## **MONTGOMERY COUNTY HISTORIC PRESERVATION COMMISSION STAFF REPORT**

Addresses:	16501 Norwood Road, Sandy Spring 16400 Layhill Road, Sandy Spring	Meeting Date:	3/20/2024
Resources:	Master Plan Site #28/14 Woodlawn Master Plan Site #23/119 Holland Store and House/Red Door Store	Report Date:	<del>3/13/2024</del> <u>3/15/2024</u>
Applicant:	Jose Thommana, MCDOT (Agent Rebecca Park, MCDOT)	Public Notice:	3/6/2024
<b>Reviews:</b>	HAWP	Tax Credit:	n/a
Permit #:	1060757 and 1060792	Staff:	Chris Berger
<b>р</b> I			1

**Proposal:** Shared-use path, lighting, and fence installation and fence relocation and stormwater management facility construction.

Figure 5: Plan Sheet 1 of 4 for the shared-used path and stormwater management facilities along Norwood Road.

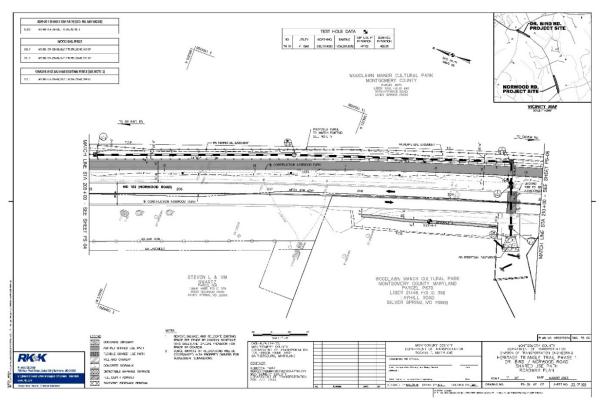
- 1. Applicant shall label the locations of the proposed lights on the plans.
- 2. Applicant shall provide a representative photo for all of the proposed stormwater management features and add their dimensions to the plans. Revised plans submitted 3/15/2024 met conditions.

Storm water management facilities will be constructed on both sides of Norwood Road. At the Woodlawn Master Plan Historic Site, three grates will be installed; the remainder of the work on that side of the road will be underground. Work at the Holland Store and House/Red Door Store will result in the installation of two grates, two storm drains, and a linear, 3-foot wide bioswale. Staff seeks a condition that the applicant provide a representative photos of all storm water management features. Staff also seeks to have the dimensions of all the storm water facilities added to the site plan.

Figure 12 – Plan view of the proposed Sidepath at the Entrance of Woodlawn Manor Cultural Park

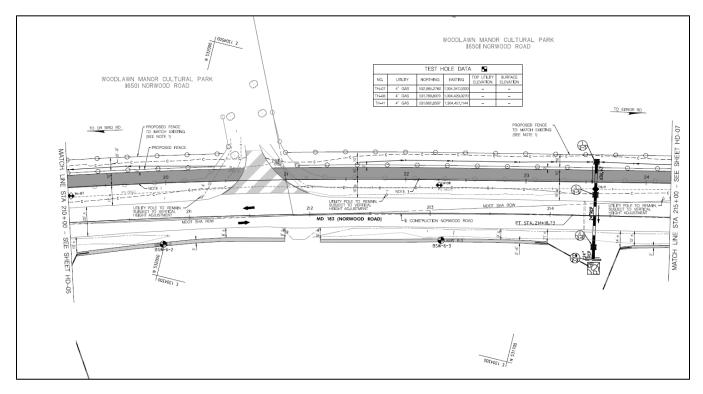
Montgomery Parks looks forward to the improved pedestrian and cycling access to Woodlawn Cultural Park, however the new path does present new challenges for safety and security. Figure 12 shows the proposed shared-use path plan view at the entrance to Woodlawn Manor. Parks Staff have noted concerns with the vehicular traffic utilizing this entrance as a cut-through and additional measures should be taken to improve the safety of the path crossing including better signage to reduce thru traffic, a marked crossing and detectable warning strips for pedestrian and cyclists, and other appropriate measures identified during detailed design. The existing signage at the entrance to Woodlawn will need to be relocated and replaced at the direction of Parks Staff.

Along the length of the east side of the path, at the request of Park Police, a double fence separated by a 10-foot width is proposed to separate the equestrian pasture from the path for the safety of both the

horses and path users. The fence must match the existing fence in design and materials. In addition, due to increased access and activity that the path will provide around the Park Police headquarters and equestrian facilities MCDOT will also provide four security cameras along the frontage of the Woodlawn Property. Finally, MCDOT will provide a trail counter along this section of the path to Parks' specification to allow for user data tracking and analysis.
